Re: Notice of Termination Approval Letter for a Portion of the Site
Pennsylvania Pipeline Project (Mariner East II)
DEP Permit No. ESG0500015001
Forward and Elizabeth Townships, Allegheny County
Jackson, Cambria, Munster, Cresson and Washington Townships, Cambria County
Burrell, East Wheatfield, and West Wheatfield Townships, Indiana County
Chartiers, North Strabane, Nottingham and Union Townships, Washington County
City of Jeanette; Municipality of Murrysville; Rostraver, South Huntingdon, Sewickley,
Hempfield, Penn, Salem, Loyalhanna, and Derry Townships, Westmoreland County

EARTH DISTURBANCE INSPECTION REPORT

Project Name Pennsylvania Pipeline Project / ME2 S1 **Inspection Date** 10/23/2021 **Inspection Time** 8:45 am

Existing water bar - spread 2.49

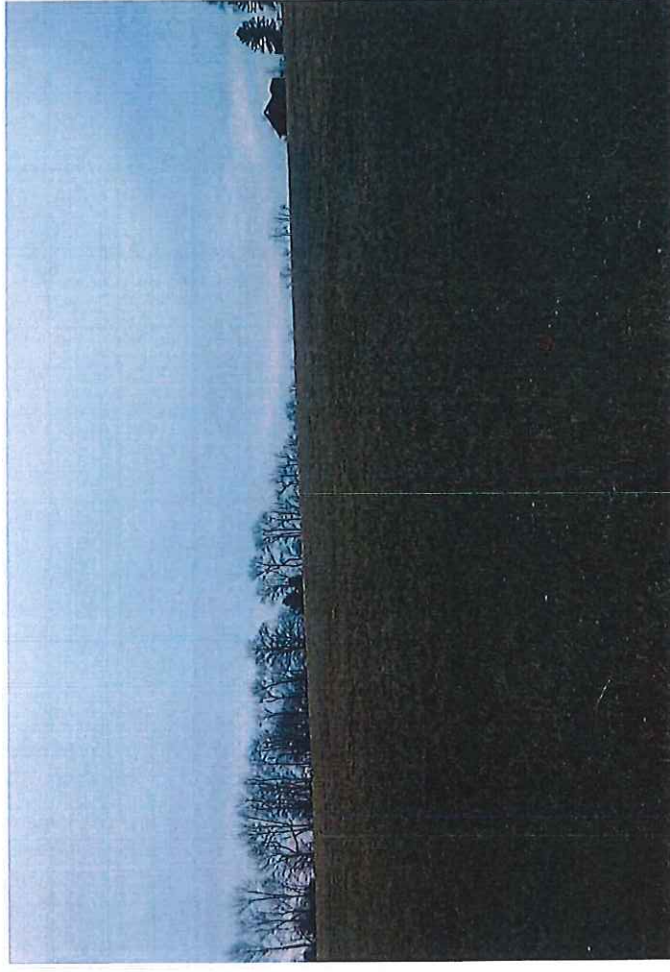
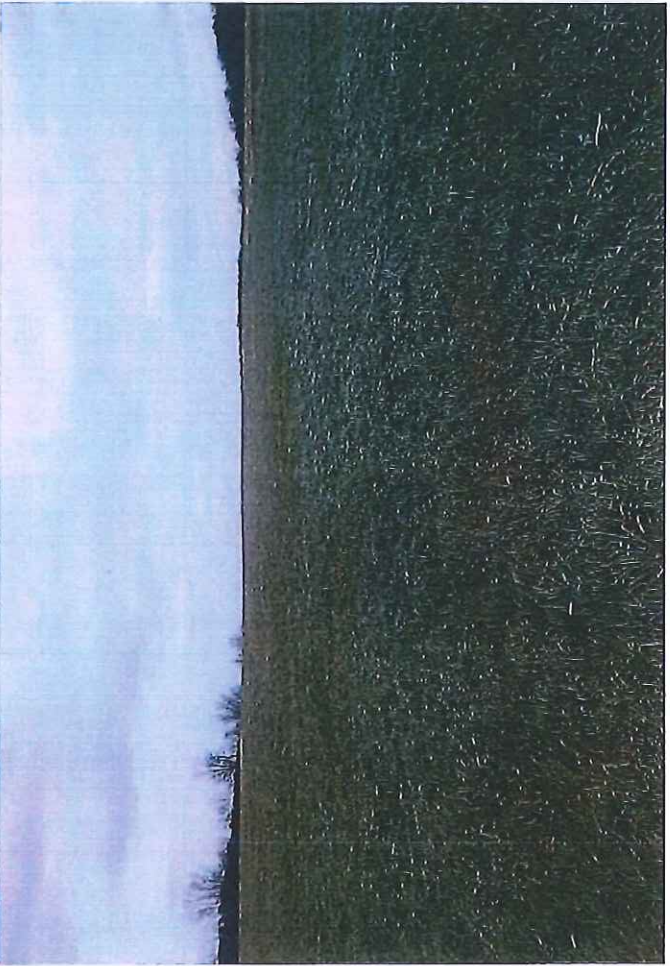
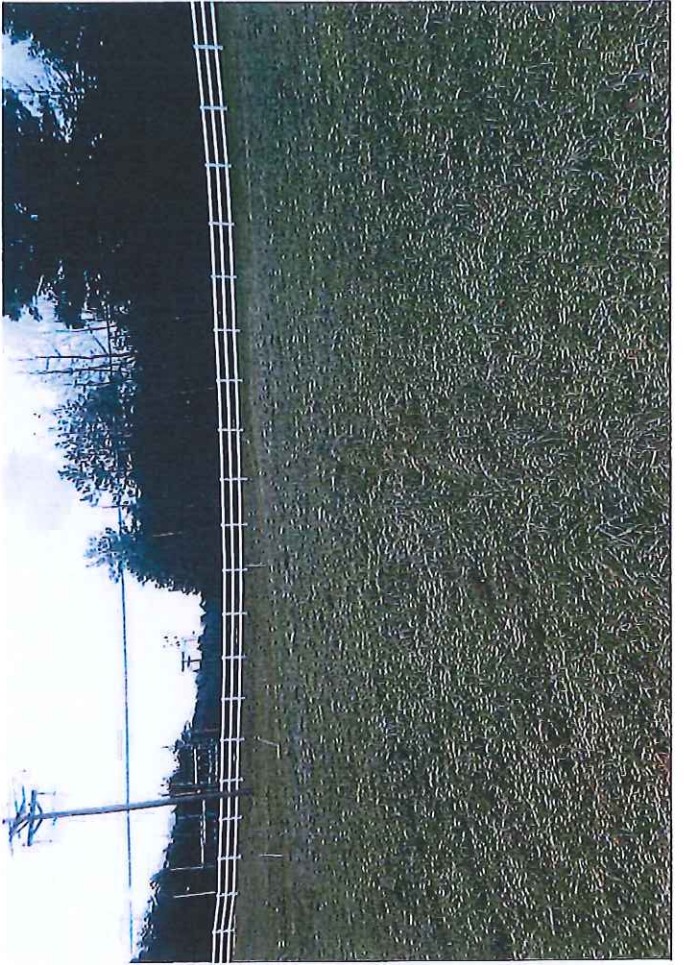
Permanent water bars: Goldfinch Berouite

Spread 2.06 disturbance

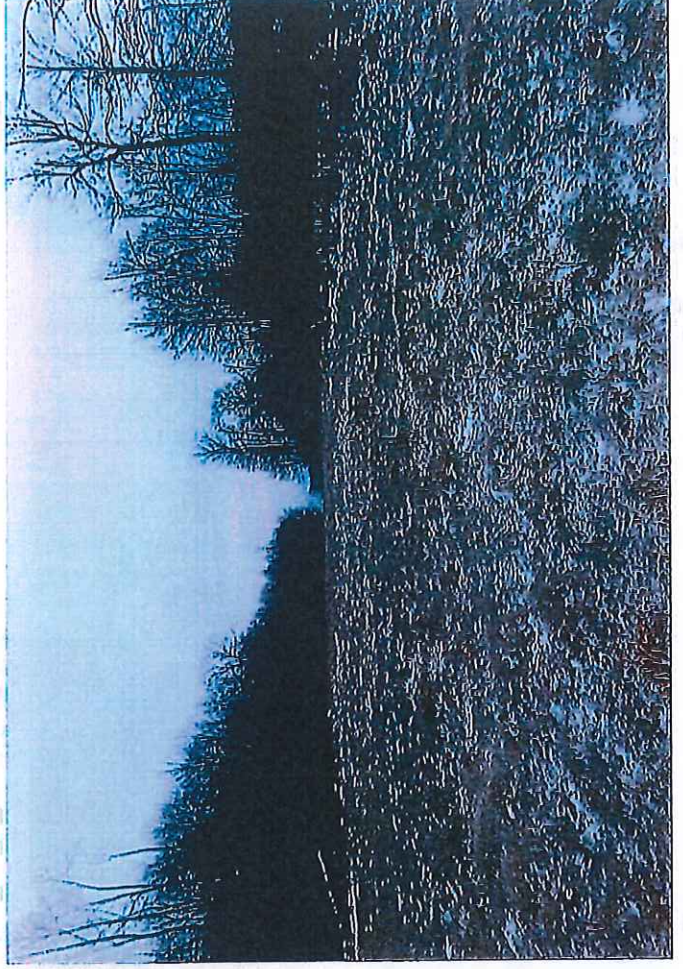
Compliance Assistance Measures The small area of disturbance within the LOD on spread 2.06 does not meet the criteria of permanent stabilization. It is recommended that plan drawings should be adjusted using a blue LOD in this area. This small area should not be terminated at this time due to the lack of vegetative cover.
